## **NC State Building Codes Amendments - Effective 1/1/2015**

**(adopted through June 2014)**

The following pages represent a summary of the Building Code Council adopted amendments that have been approved by the Rules Review Commission.

**SECTION VIEW OF METAL FRAME ROOF:  
FILLED CAVITY FIBERGLASS INSULATION**

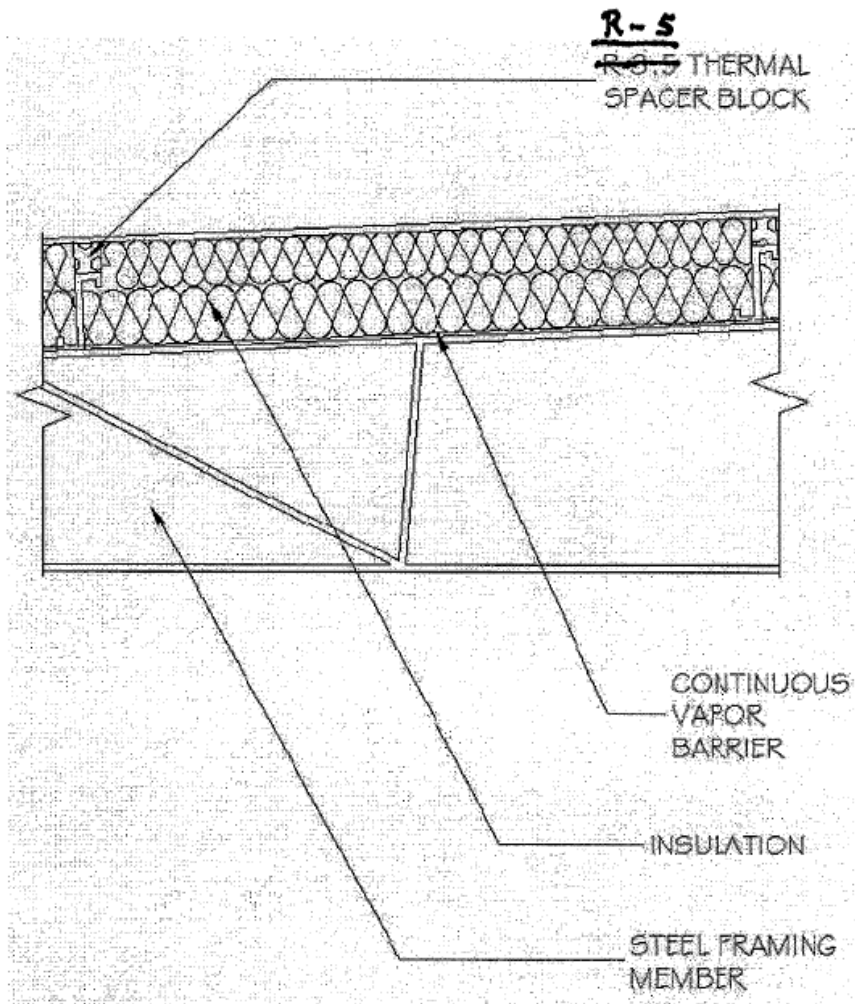
ROOFS	DESCRIPTION
R-44 <u>10</u> + R-19 FC	Filled cavity fiberglass insulation. A continuous vapor barrier is installed below the purlins and uninterrupted by framing members. Both layers of uncompressed, unfaced fiberglass insulation rest on top of the vapor barrier and are installed parallel, between the purlins. A minimum R-3.5 thermal spacer block is placed above the purlin/batt, and the roof deck is secured to the purlins. Drawings of typical details are shown in Appendix 2.2.

Revise Appendix 2.2 as follows:

**FIGURE R403.3 (1)  
CONCRETE AND MASONRY FOUNDATION DETAILS**

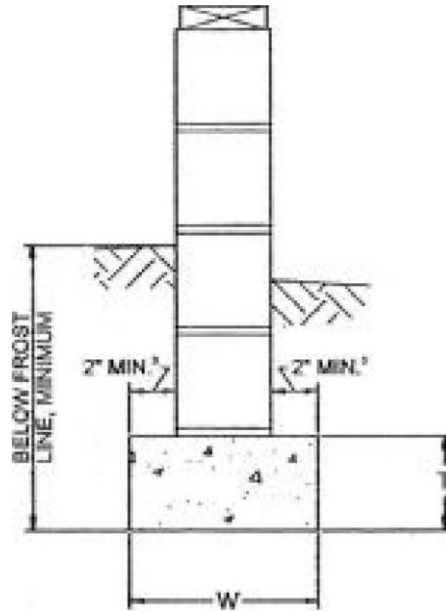
1. Foundations shall extend not less than 12 inches below ~~the natural grade or engineered fill~~ finished grade and in no case less than the frost line depth.  
REMAINING NOTES TO REMAIN THE SAME
